From: [Ian Higgins](mailto:ian.higgins@ci.carpinteria.ca.us)
To: publiccomment@ci.carpinteria.ca.us; [SBCAG Information Requests](mailto:SBCAG.Information.Requests@coastal.ca.gov); meagan.harmon@coastal.ca.gov; roberto.uranga@coastal.ca.gov; rick.rivas@coastal.ca.gov
Subject: Agenda item #2 / Rincon Multi use trail proposal
Date: Monday, January 17, 2022 8:17:07 AM

RE: Agenda item #2 Rincon Trail Project

FIGURE 1

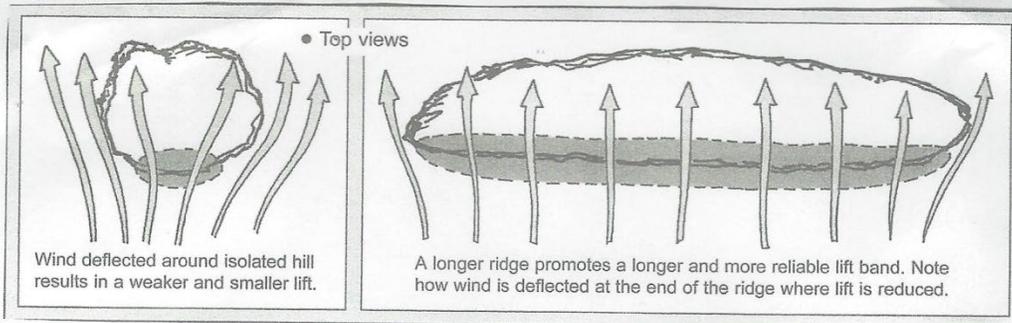
1. The most important misconception in this EIR analysis is that it is limited to two dimensions. In other words, it only looks at the vertical and incoming flow of the air. However, we all know that the flow of air is so fluid that it moves in all directions—forward and back, left and right and up and down. Because this site is limited in its width with respect to the incoming wind (perpendicular to the slope face), there will be some flow moving slightly sideways to escape into the opening or gap near the railroad tracks as a result of the extensive excavation needed to connect the bridge to the path. We can visualize this phenomena by thinking about a rock in the middle of a fast flowing stream. In this case we will see a bit of pile-up of water in front of the rock, while most of the water splits to flow around either side of the rock. The air flow around a protruding hill is nearly identical to this observed water flow. Figure 1 illustrates this effect.

If we further visualize a broader rock or perhaps a short wall perpendicular to the water flow, we will see that there will be more pile-up of water in front of the obstruction (wall), while there is still plenty of water that escapes around the sides of the wall. In the free air flow the wall is analogous to a ridge as opposed to a single hill limited in width. It should be clear that the wider the obstruction, the more it presents lift in front of it, and the smaller the percentage of flow that escapes around the sides compared to the total volume of flow meeting the obstruction face.

FIGURE 2

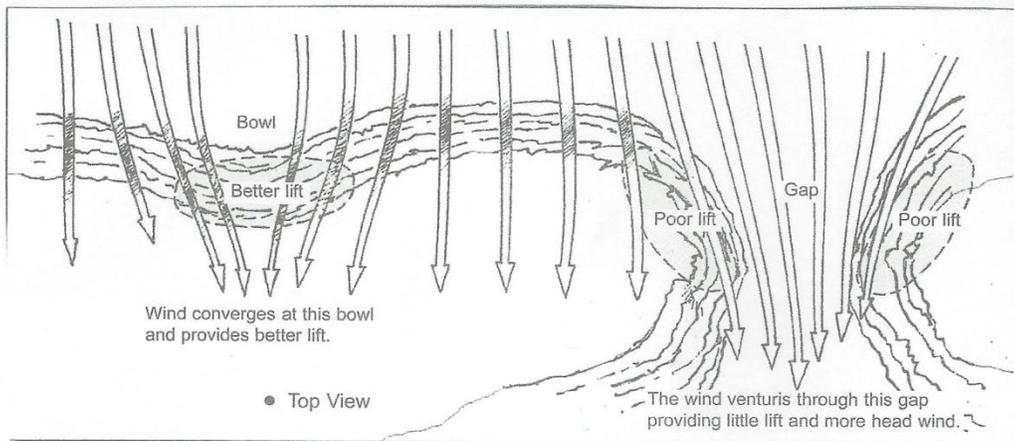
This natural behavior of water and air means that any alteration in the width of the small ridge at this particular soaring site will render it less soarable and undesirable as a flying site. In fact, it may become non-soarable except in a perfect wind direction (an infrequent occurrence at this site) or higher winds, which increases the inherent dangers. Not only is the lifting area reduced, but the increased flow into the proposed larger gap near the RR tracks will make it harder and more dangerous to cross the gap to reach the higher, more soarable area of the ridge. It should be noted that all craft operating in a fluid (boats and aircraft) must point a bit into the flow in order to move in a direction crossing the flow. With a higher wind flow in this gap, the crossing will be slower and may not be possible at all if the glider's energy and altitude is expended in countering this increased air flow. Figure 2. Illustrates this matter.

Another factor that the three-dimensional flow introduces is that lift is reduced due to some sideways flowing of the air. So while the diagrams presented in the EIR purport to show a 10 to 20% reduction in lift, it will be a greater reduction if any amount of the ridge width is reduced. In other words, the graph presented are not representing the true effect of the proposed alteration of this site. When air flows faster in a constricted tube or through a narrow gap, it is known as a venturi effect. Pilots learn to avoid venturis because of the inability to penetrate against them and the possibility of stronger and even dangerous turbulence. This result is similar to an airplane flying into a jet stream with its extremely strong flow and often strong turbulence.
